UNITED STATES PATENT AND TRADEMARK OFFICE

APPLICATION NO.	FILING DATE	FIRST NAMED INVENTOR	ATTORNEY DOCKET NO.	CONFIRMATION NO.
09/677,058	09/29/2000	Edward Friery	14097	1687

Office Action Summary

DETAILED ACTION

FIG-3

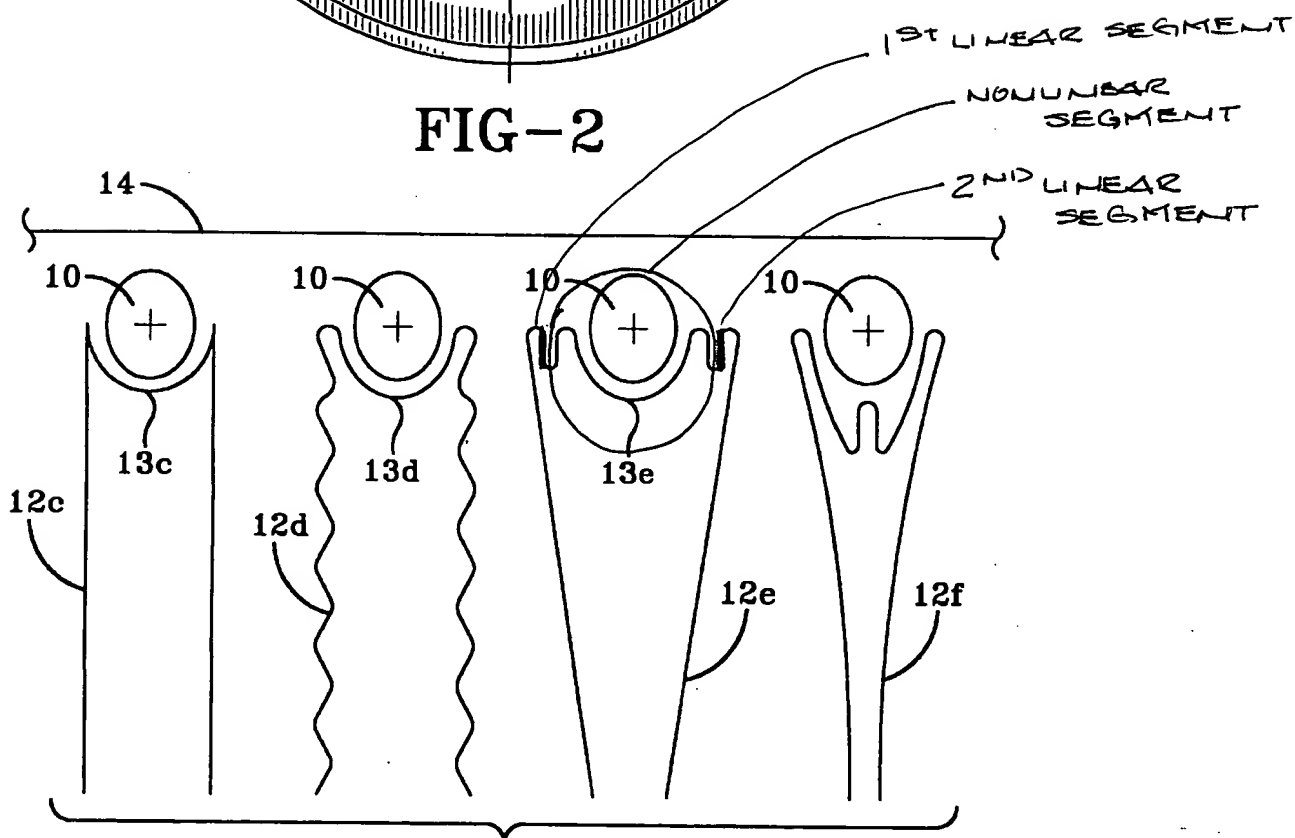
The reference does not disclose the seam as including a nonlinear portion with a plurality of bends in alternating directions, while Ross shows these seams 12d/13d in fig

3. These seams also include sharp corners - ends of segment 13d.

Re Claims 4-7, Nicholas does not show particular linear/nonlinear segments, while Ross shows these characteristics in seam 13e in fig 3, where

- a. the nonlinear portion comprises first/second linear segments proximate the first/second ends of this portion, and,
- b. the nonlinear portion comprises a nonlinear segment between the first and second linear segments,

as identified in the attached drawing of Ross.

Re Claim 10, while the references do not explicitly disclose the seam with bends having nonuniform size and shape, this configuration would have been obvious in light of fig 3. It is obvious that curves/bends may be varied to conform to particular timing parameters and/or applications, and this characteristic does not solely affect the general function of the invention.

Re Claims 11-13, Nicholas does not show particular portions of the nonlinear portions, while Ross shows these portions 12c,

First/second linear side portions perpendicular, and adjacent to,
first/second ends of nonlinear portion 13c.
